## PUBLIC WORKS ADVISORY BOARD Agenda

**Tuesday, February 13, 2024 – 4:30 P.M.**

a. East Portal 30% Design review.

b. Barclay Drive design, Larch to Locust phase.

**Signing, Striping, and Illumination Exhibit**  
 BARCLAY DRIVE IMPROVEMENTS

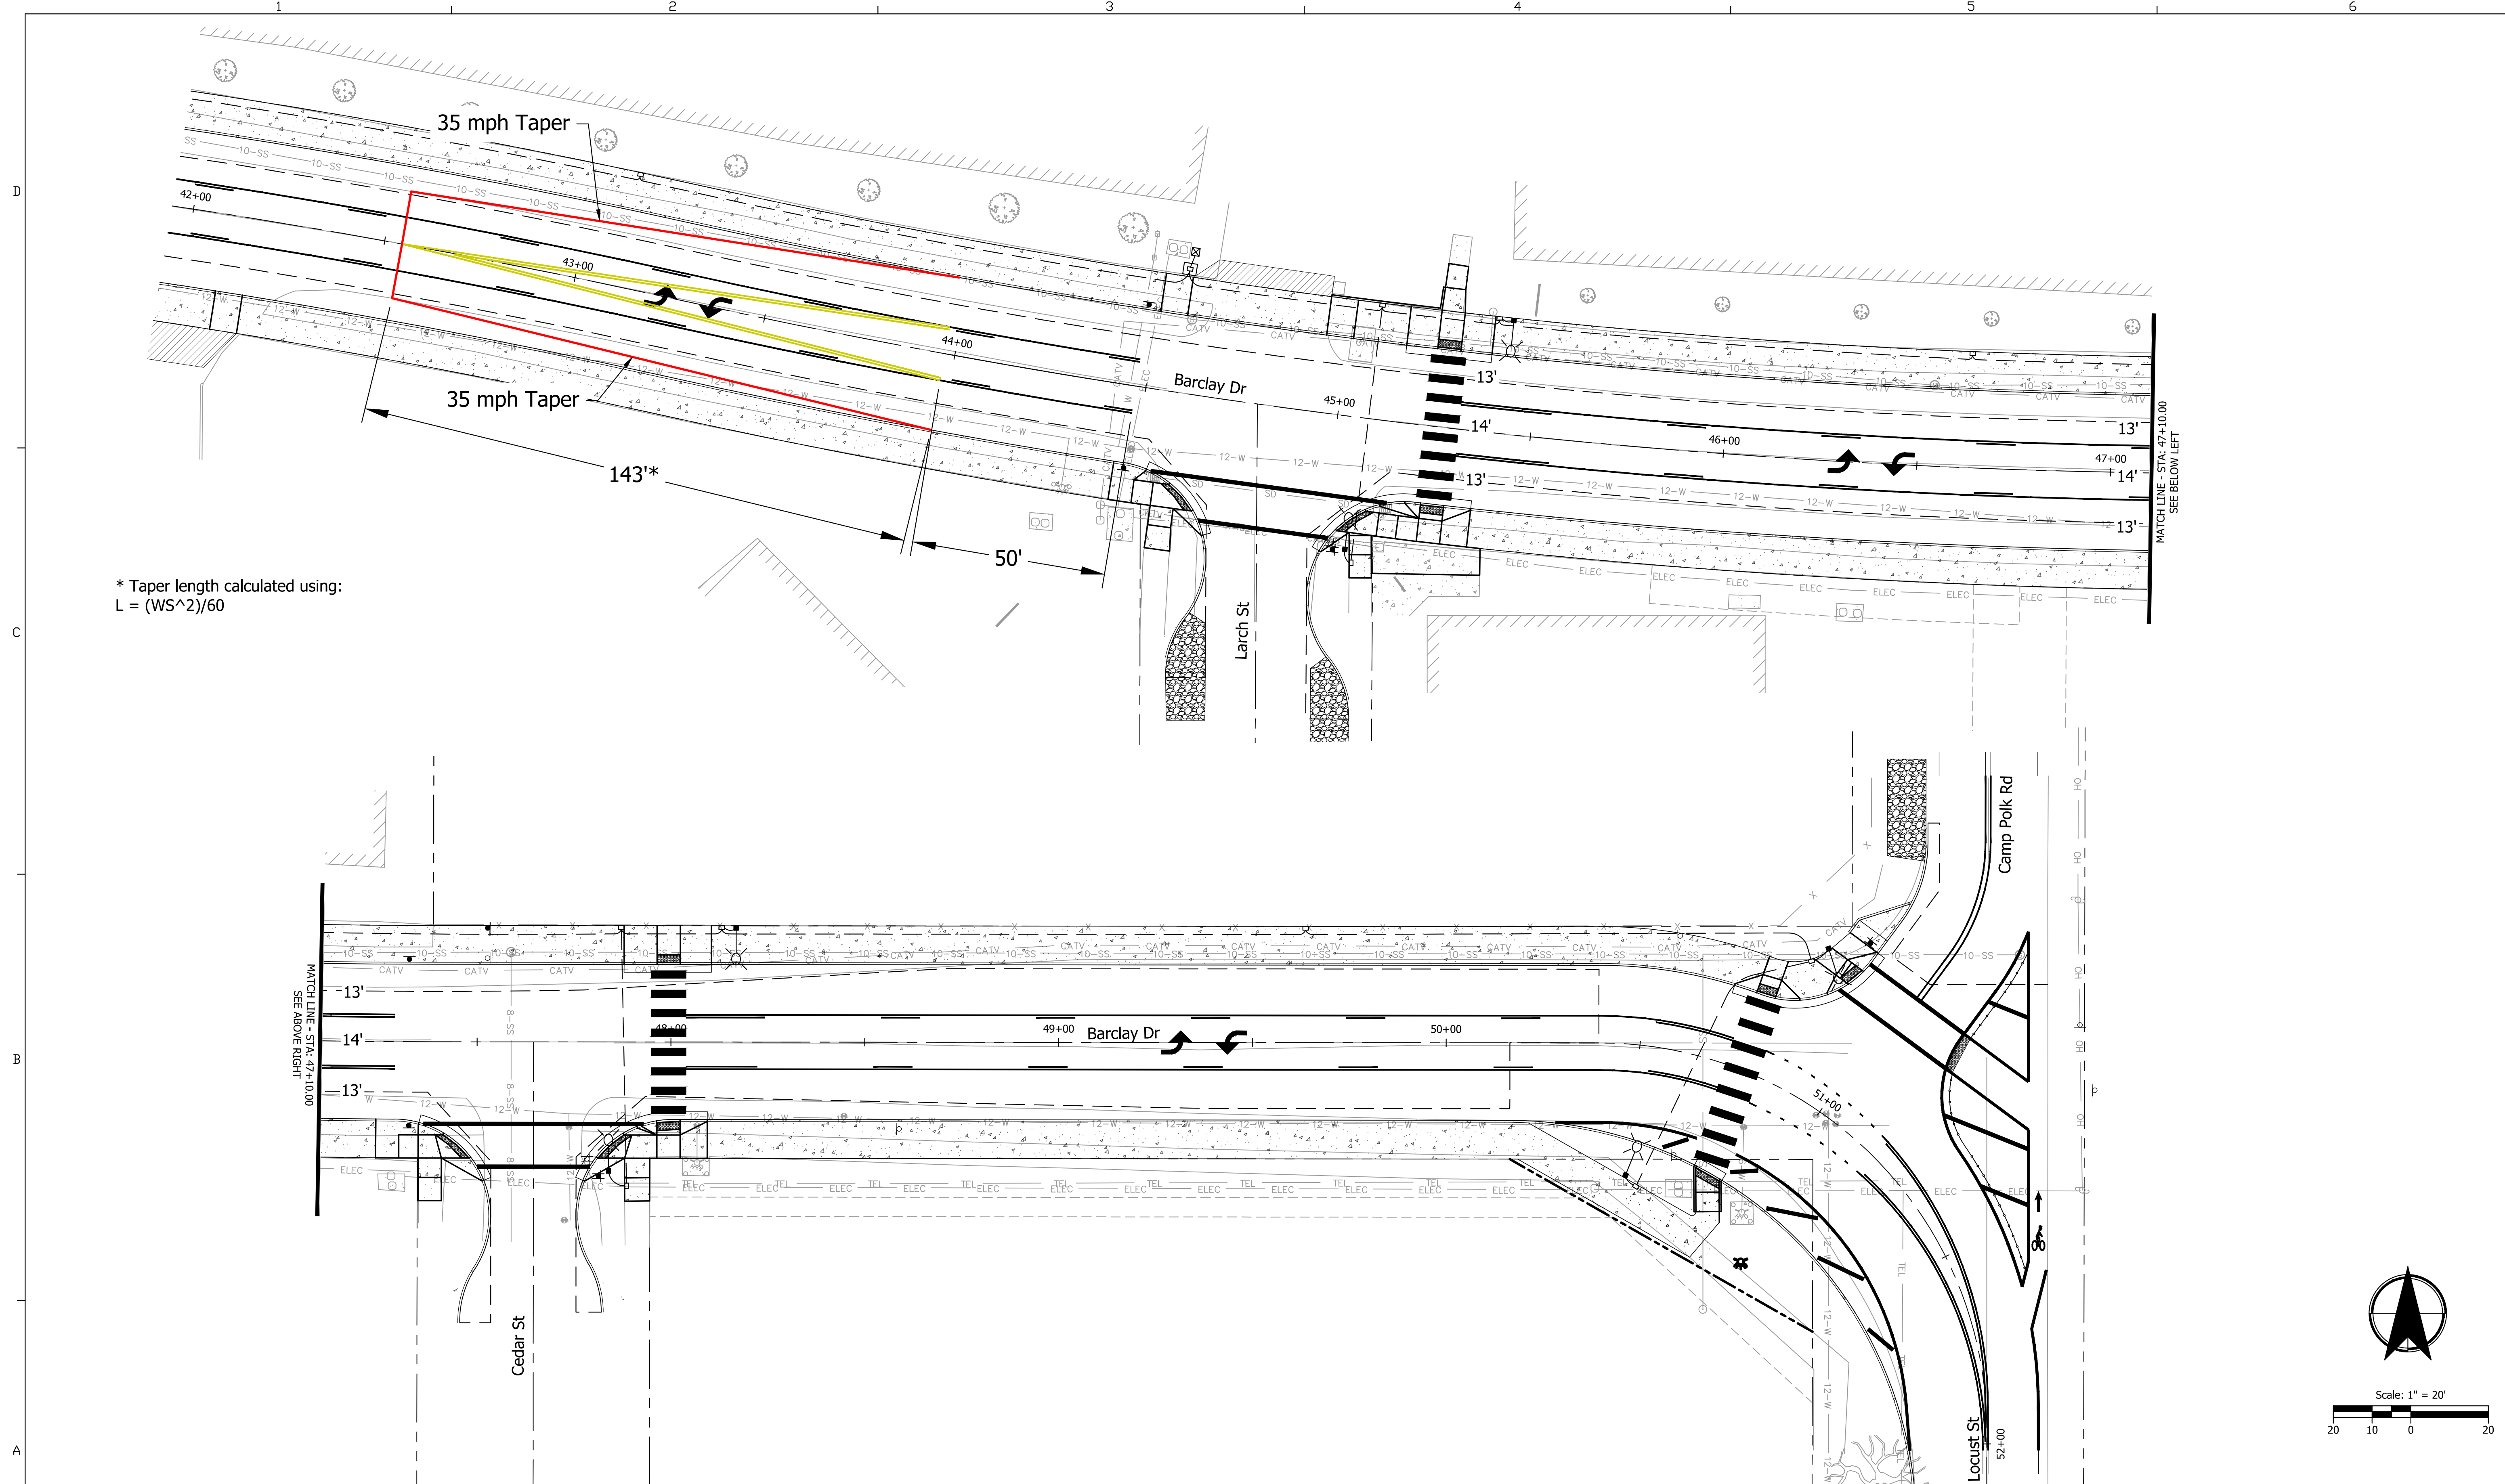
For the sake of pedestrian safety and supporting alternative transportation around town, **I highly encourage the Public Works Advisory Board and staff to consider some low-cost, incremental improvements to the western part of Barclay Drive that can be implemented now while awaiting new funding.** Specifically, I recommend the following:

- 1. Add painted crosswalks** across Barclay on the west side of N Larch St (currently only a marked crosswalk on the east side) and on the east side of Sun Ranch Dr. (currently no marked crosswalks on either side). This would improve connectivity between existing off-street pedestrian pathways.

- 2. Add pedestrian warning flashers for westbound traffic approaching N. Pine St.** The curve in the road here, plus a private fence on the north side of the street, makes it hard for westbound traffic to spot pedestrians until it's too late to stop. Flashers before the curve might help put drivers on alert.

- 3. Reduce the speed limit along Barclay.** Barclay Drive is one of the fastest streets within city limits, and one of the few with a 30 MPH limit. Currently, a vehicle heading west through town via the "business route" has to go from 20 MPH on Highway 20, to 25 MPH on Locust St, to 35 MPH on Locust St (once past Green Ridge Physical Therapy), back down to 30 MPH on Barclay, and then back up to 35 MPH once reaching the existing roundabout. I recommend a consistent 25 MPH
